Customer Safety Advisory Notice MR072/23/S

SAFETY ADVISORY NOTICE

Customer Information about possible artifacts from over-ear headphones during head examinations

Figure 1: Location of model number and serial number on over-ear headphones

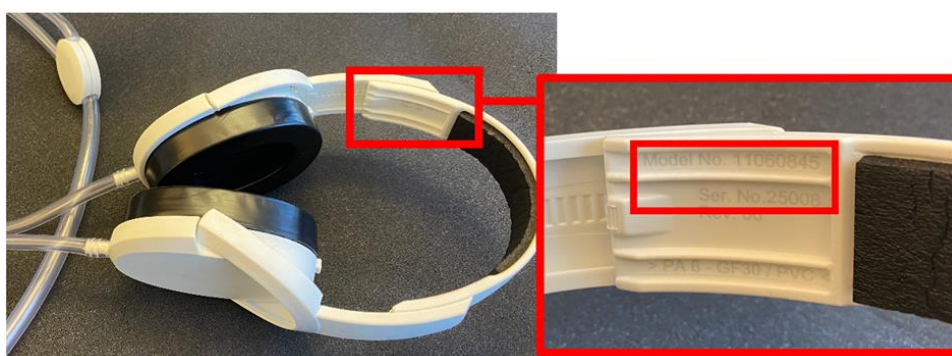
- Check the model number and serial number of your over-ear headphones. See *Figure 1* for their location on the over-ear headphones. If the model number is not identical or the serial number is outside the stated range (7981 – 32200), they are not affected.

Figure 2

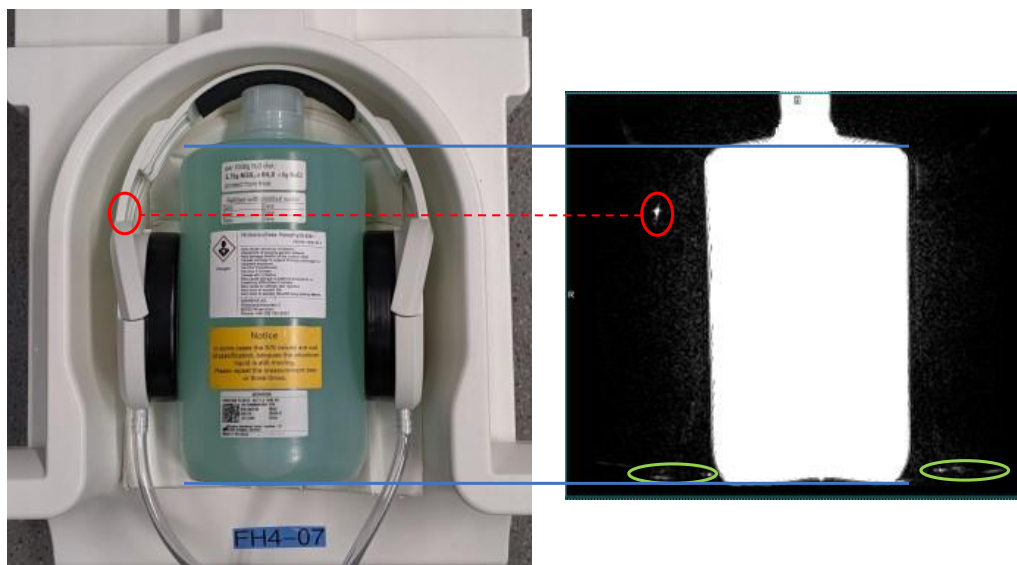
- Set up with phantom bottle and headphones as shown in *Figure 2* below.
 - Use the standard sequence t1_fl3d_sag_p2_iso (from Siemens protocol tree: head → library → 3D) with the minimum possible echo time TE, repetition time TR of 10 ms, field of view (FOV) of 250 mm and coronal orientation.

- Apply window values of approx. C=20 and W=10 to identify if artifacts from lubricating grease clumps are present outside of the skull at the position of the headband of the headphones.

Right side: Example of signal from lubricating grease can be seen outside the phantom, marked with a red circle. The artifacts must be on the same height as the potential affected headbands of the headphone.

Please note: MR imaging often shows artifacts with phantom bottles in this extreme windowing e.g., at the top and/or bottom of the phantom. These artifacts are marked with green circles in the above example and can be ignored.

- ➔ **If no artifacts are visible** during the described phantom measurements, your over-ear headphones are not affected and can continue to be used for MRI head examinations.

- ➔ **If artifacts are visible** during the described phantom measurements, your over-ear headphones are affected and must not be used for head examinations. In this case, please use the built-in loudspeaker in the scanner for patient communication or, if available, in-ear headphones which are also not affected by the described issue.
